TABLE OF CONTENTS

## INTRODUCTION AND EXECUTIVE SUMMARY

Management Analysis Company (MAC), under Contract No. CP10-0619 with Consumers Power Company (CPCo), provided consulting services relative to the Midland Project Quality Assurance Program. The consulting services involved the performance of the following three tasks:

### 3.6 Weld Profiles

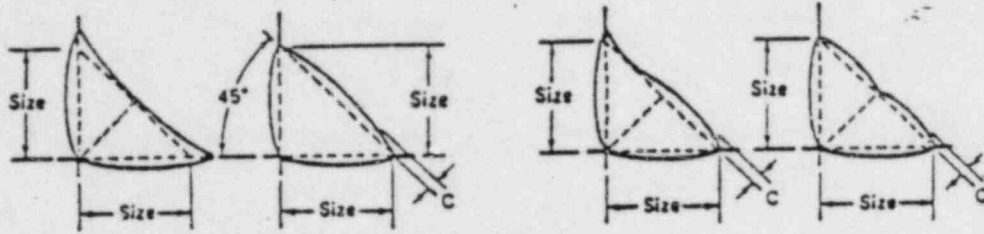
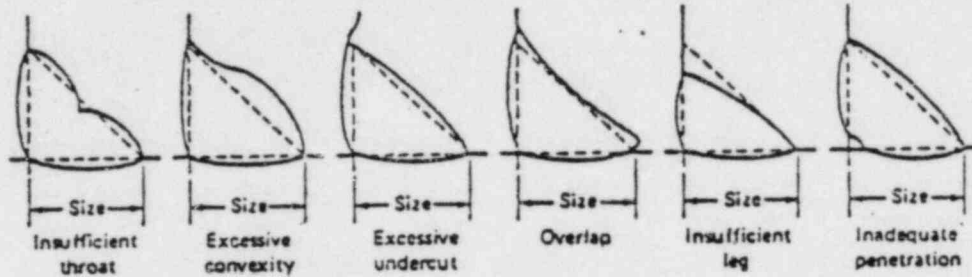
3.6.1 The faces of fillet welds may be slightly convex, flat, or slightly concave as shown in Fig. 3.6 (A), and (B), with none of the unacceptable profiles shown in Fig. 3.6(C). Except at outside corner joints, the convexity shall not exceed 0.1 times actual leg size, or the longer leg in the case of an unequal leg fillet weld, plus 0.06 in. (1.5 mm). See Fig. 3.6(B).

Fig. 8.15.1.5 — Permissible undercut values for buildings

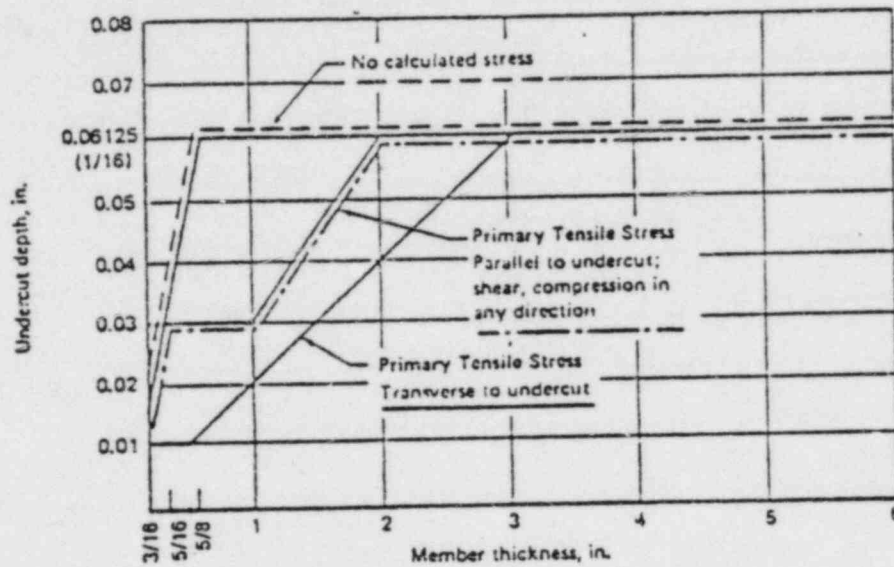
**8.15.1.9** Visual inspection of welds in all steels may begin immediately after the completed welds have cooled to ambient temperature. Acceptance criteria for ASTM A514 and A517 steels shall be based on visual inspection performed not less than 48 hours after completion of the weld.
